Index 646-001 Aluminum Pedestals and Posts – Pedestrian Detectors and Signals

COMMENTS AND RESPONSES

PLAN VIEW
SECTION B-B

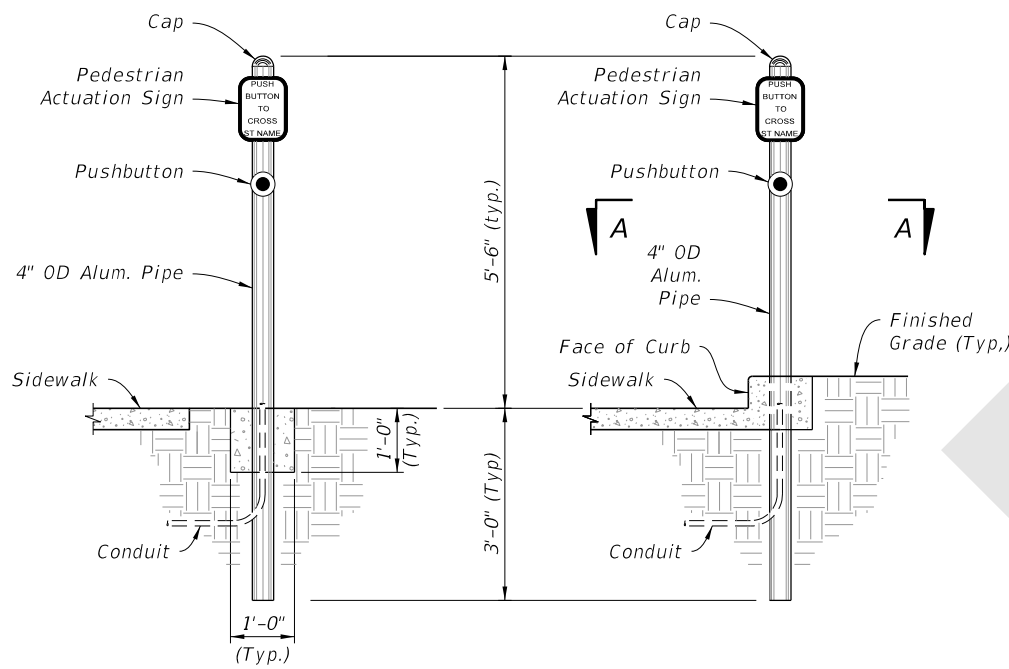
4. The plan view B-B does not match the side elevation and vice-versa. Suggest that the details be shared with structures as they are not constructible as shown. Also with the construction tolerances it may not be easy to achieve the 2 inch clearance shown from anchor bolt to face of curb. Note that a 2 ft diameter hole would have to be excavated, a cage installed and concrete placed probably just to the bottom of the curb elevation before the rest of the concrete is formed and placed. These details need to be further developed before becoming a Standard Plan.

RESPONSE: The comments have been reviewed and additional information has been added to the index to address.

Change made to Index: Added additional information to address concerns.

POST MOUNTED

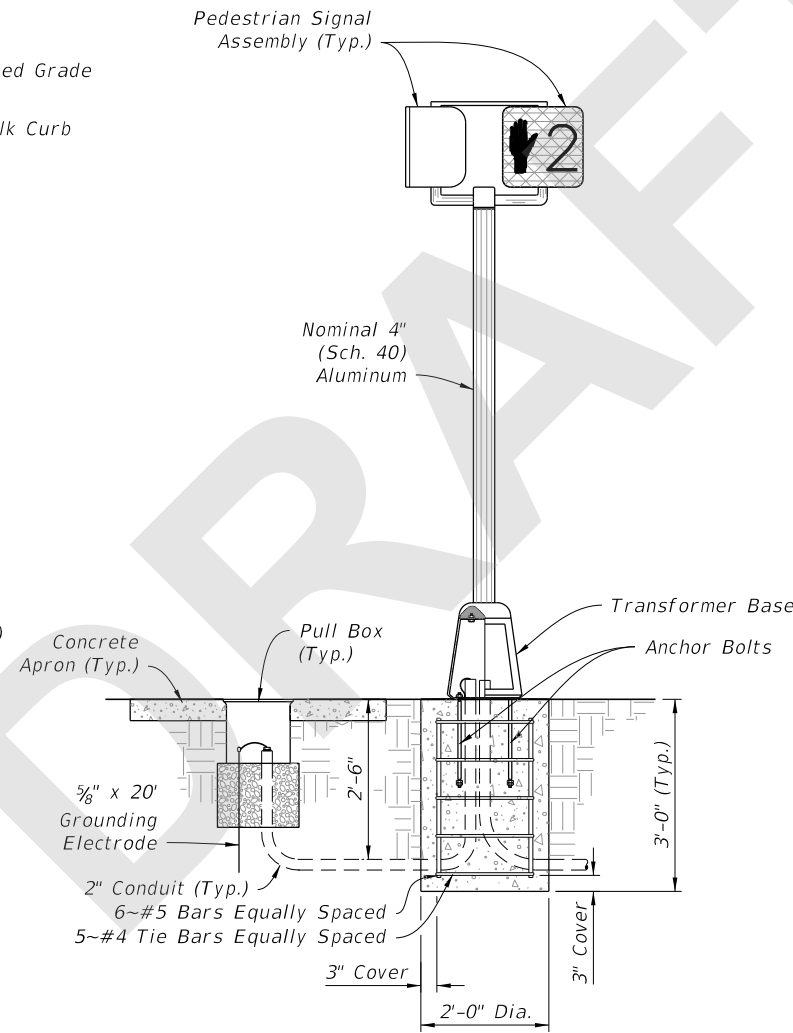
COMMENT: sheet 1 - Dimensions for the Post mounted sign in sidewalk curb are not shown- consider to show dimensions

RESPONSE: Agree

Change made to Index: Will update dimensions for clarity.

PEDESTAL MOUNTED

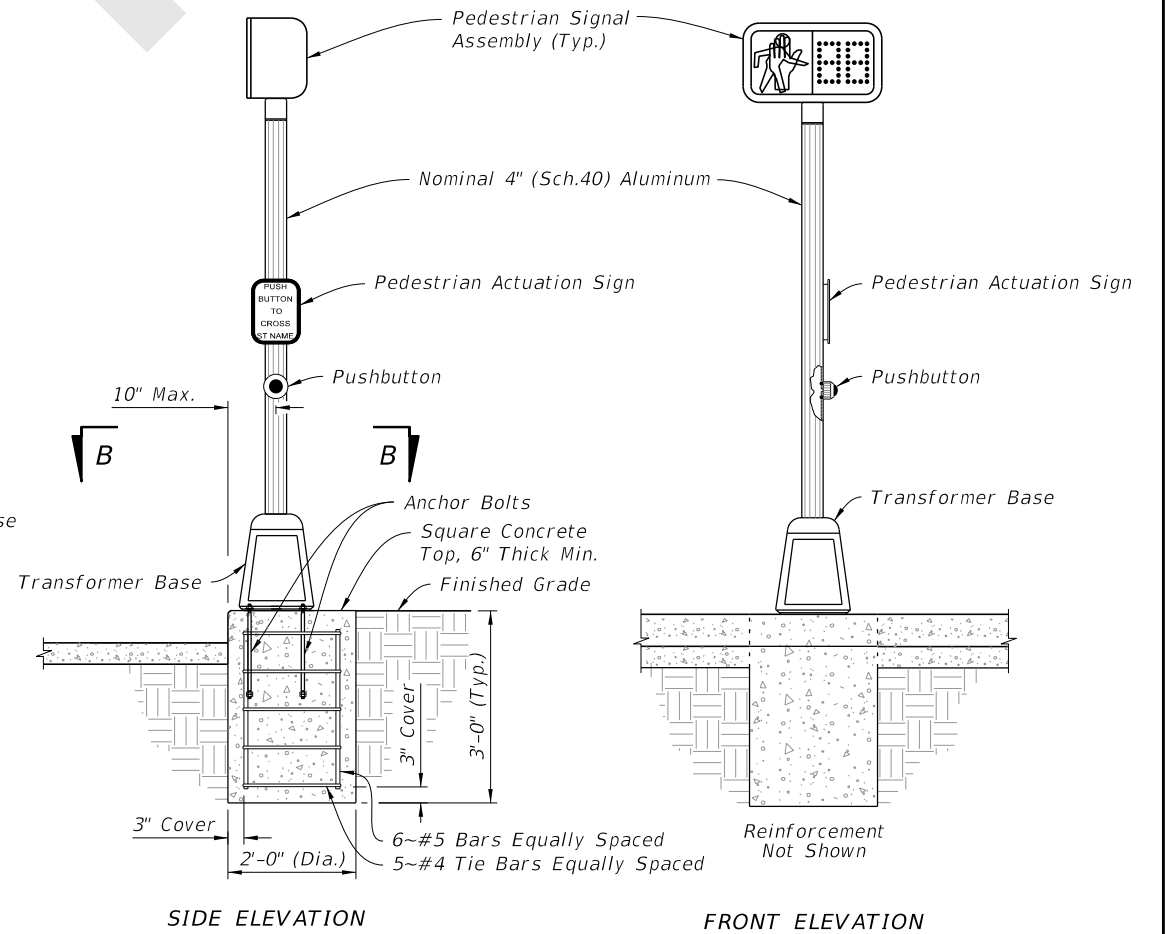
1. Pedestal mounted side elevation has references to Note 5 and Note 6 but only 4 notes are available on the sheet.
2. The Pedestal mounted in sidewalk curb side elevation is not constructible with the joints as shown. Also these joints, if within the footing as shown, would provide too many paths for water intrusion and contribute to corrosion of the anchor bolts.

3. The top stirrup in Side Elevation of Pedestal mounted in curb is different and appears to go around the outside cage but somehow wrap around the anchor bolts.
